Product hierarchy no. *			Part no.	SBU	Type / Description	Customer part no.
SBU	PG	PGU	Type			
02	006	016	0000001603	See list below	DF12 Power Entry Modul

### 3 Detailed description of change

Product Change Notification					PCN DF12		
owner	creation date	release date	released by	change order no	rev	page	D10-014-153
sariogar	14.05.2018	14.05.2018	blumhe	2015379	B	1 of 2

Old terminal arrangement on TA45 (two unprotected poles)	New terminal arrangement on TA45 (one protected pole)
Old label on TA45 (not visible)	New label on TA45 (not visible)

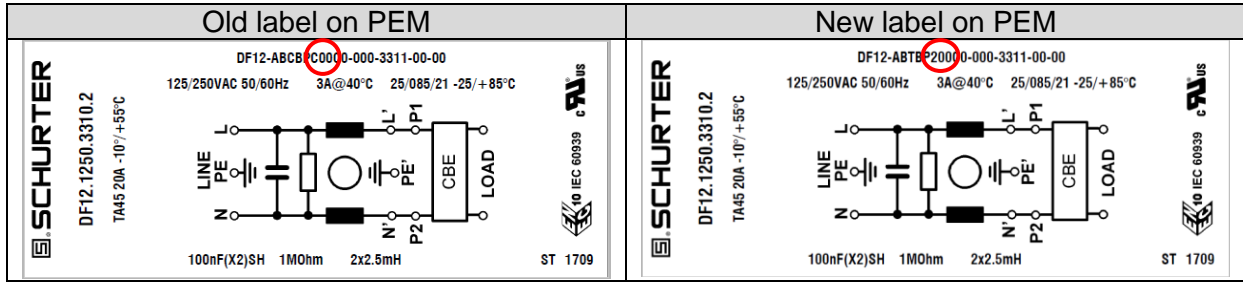
Therefore SCHURTER has decided to equip all switch types with an additional bimetal.

2-pole types will be equipped with one 20A bimetal.

TA45: Configuration Code change from TA45-XXXXX**C00**XX to TA45-XXXXX**200**XX

DF12: Configuration Code change from DF12-XXXXX**C00**XX-XXX-XXXX-XX-00 to

DF12-XXXXX**200**XX-XXX-XXXX-XX-00

Please be aware the position of the terminals will change.
